CITY OF CODY  
PLANNING, ZONING AND ADJUSTMENT BOARD  
TUESDAY, October 12, 2022  
SPECIAL MEETING  
CITY HALL COUNCIL CHAMBERS @ 12:00 NOON

**CITY OF CODY  
PLANNING, ZONING AND ADJUSTMENT BOARD  
STAFF REPORT**

<b>MEETING DATE:</b>	OCTOBER 11, 2022	<b>TYPE OF ACTION NEEDED</b>	
<b>AGENDA ITEM:</b>		P&Z BOARD APPROVAL:	
<b>SUBJECT:</b>	PRELIMINARY PLAT OF THE MEADOWLARK MEADOWS SUBDIVISION— A 28-LOT SUBDIVISION. SUB 2022-07	RECOMMENDATION TO COUNCIL:	X
<b>PREPARED BY:</b>	TODD STOWELL, CITY PLANNER	DISCUSSION ONLY:

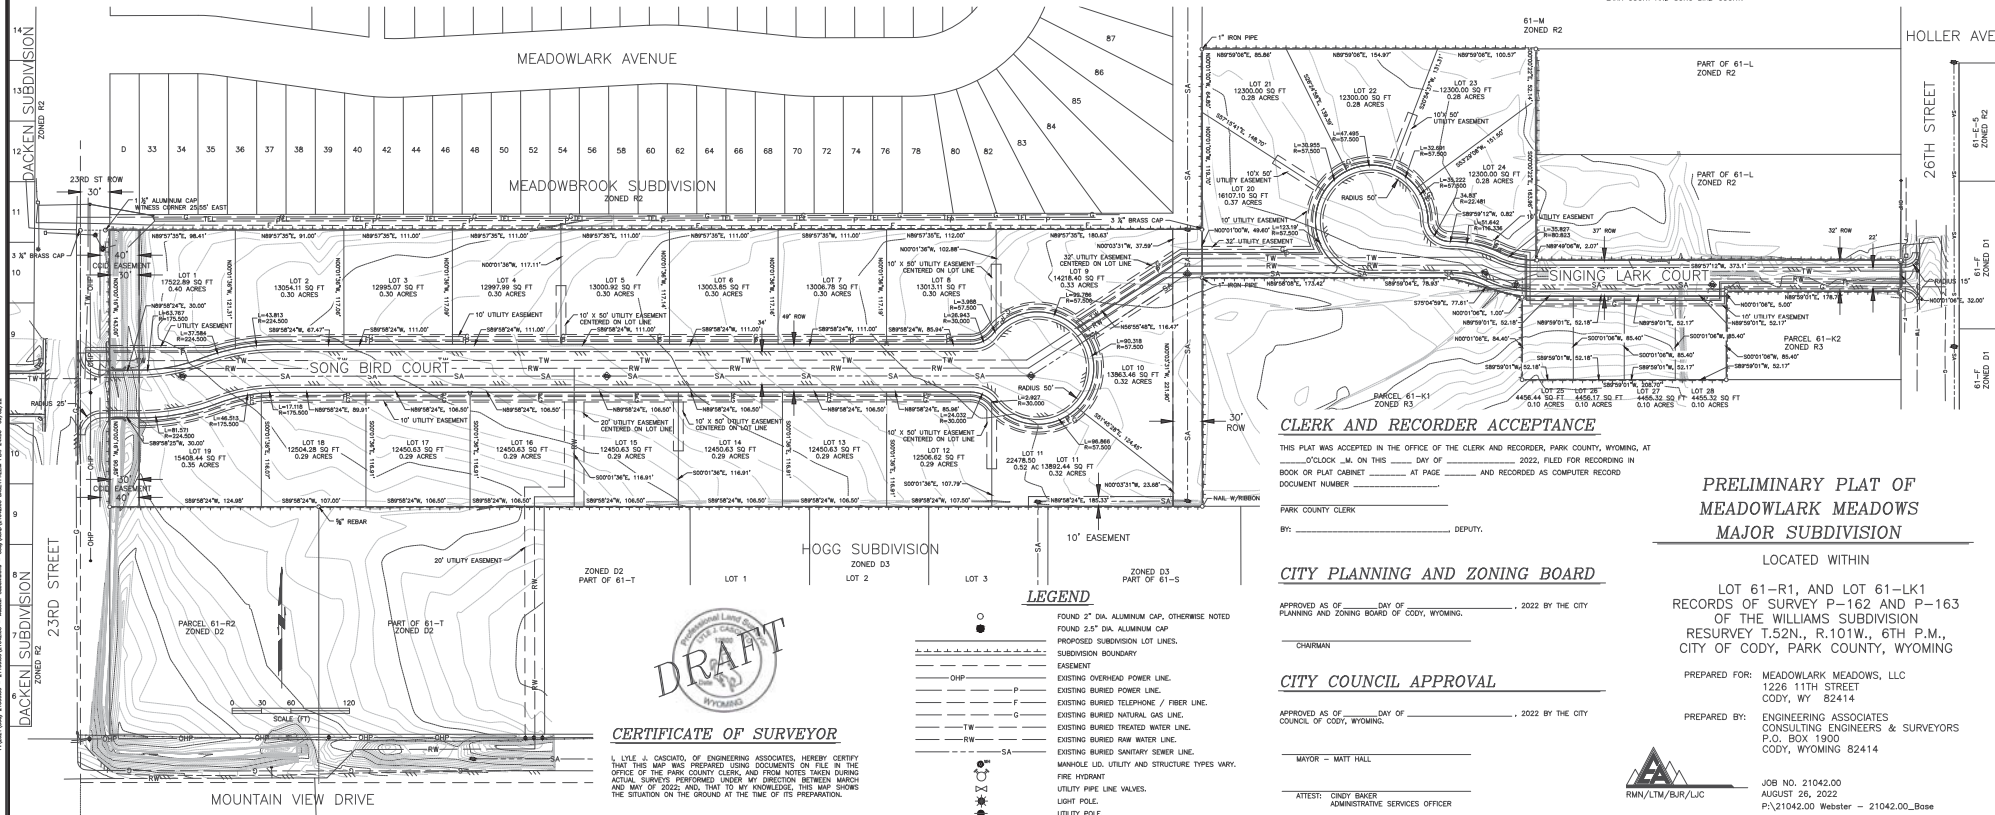
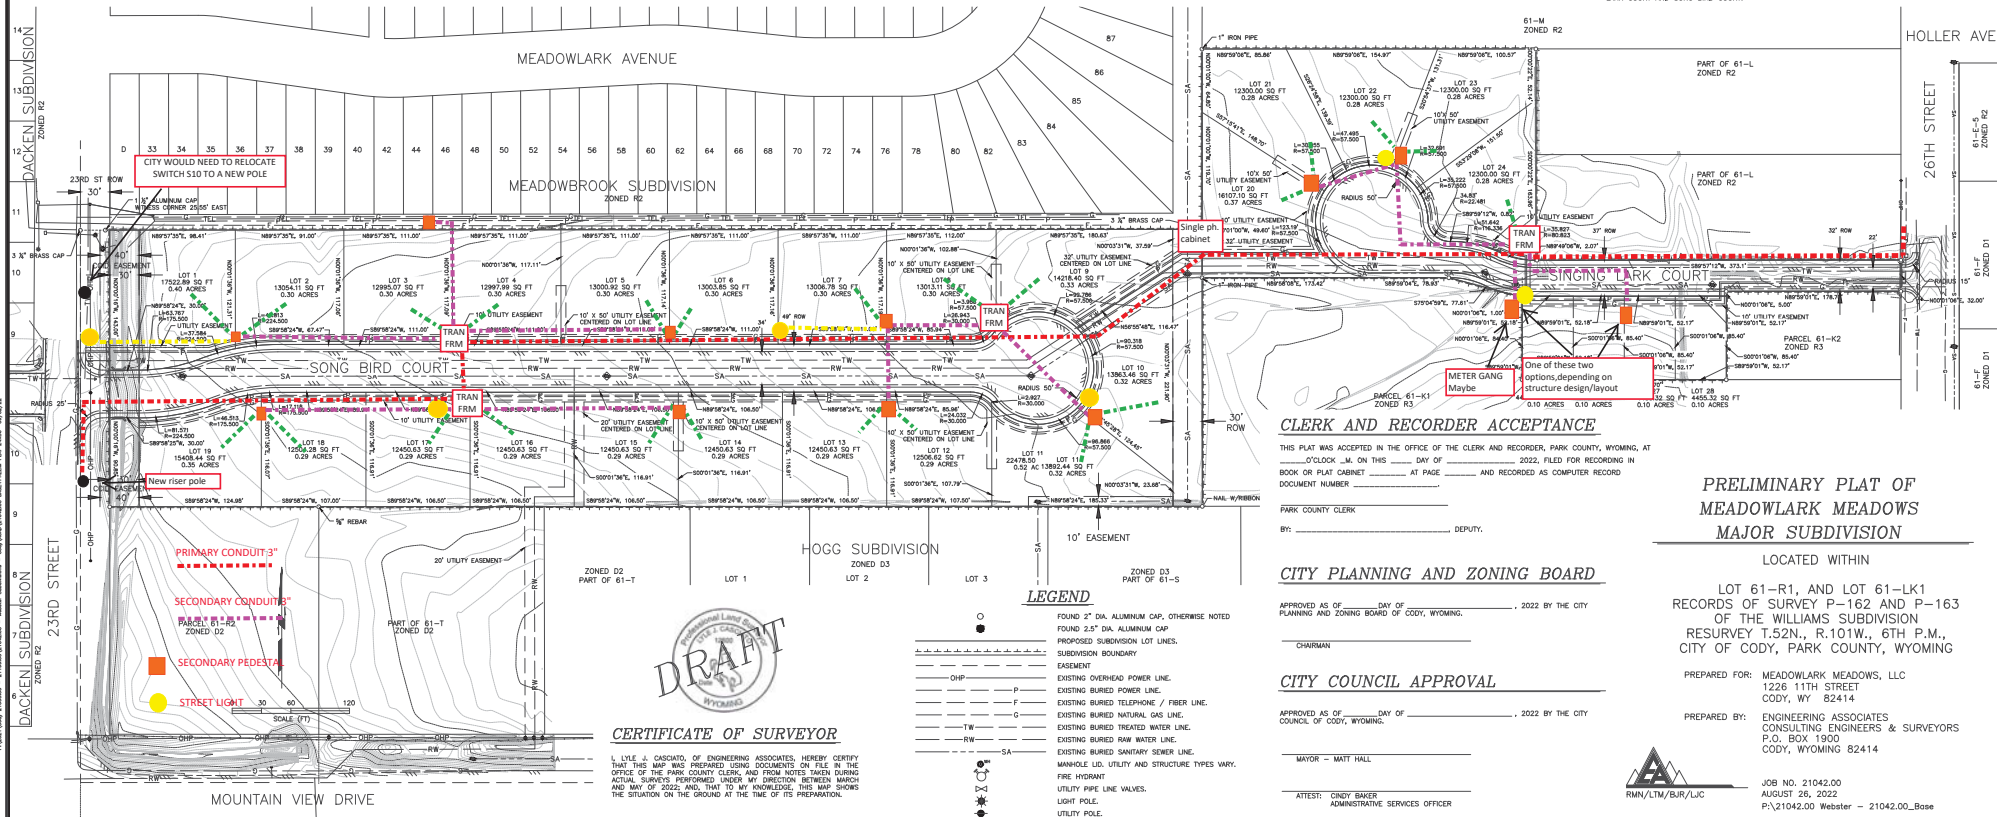
The 49-foot width shown for Songbird Court needs to be widened to 50 feet, so as to avoid having to offset the survey pins. The 32-foot right-of-way width for Singing Lark Court needs a variance to be allowed.

Comment: The preliminary plat did not show any individual utility services, only the mains. Review will occur with the construction plans and final plat.

The preliminary plat did not identify a small irrigation ditch/drain that crosses Lot 28 and Singing Lark Court. It is part of a McMillin Irrigation Company system. The ditch/drain will need to be accommodated per their standards, and if it remains within the subdivision, it must be piped.

- 1) Modify the Singing Lark Court right-of-way to accommodate the potential double-bulb configuration just mentioned.
- 2) Expand lots 9, 10, and 11 into the sewer easement/R-W, and modify the dimensions accordingly.
- 3) Correct the width dimensions on Lots 1 and 19.
- 4) Reduce the raw water easement from 20' to 15' and shift it to be entirely to one side of any lot line.

- 5) Relabel the 10' by 50' easements, as "drainage" instead of "utility", shift each to be entirely to one side of any lot line, and reconfigure based on the stormwater calculations and the language in this report. Coordinate locations to avoid utility conflicts.
- 6) Add the recording information for existing easements.
- 7) Widen the right-of-way of Songbird Court to 50 feet.
- 8) Change "Song Bird" to "Songbird".
- 9) Add a 10-foot utility easement for the electric line on Lot 3 or 4.
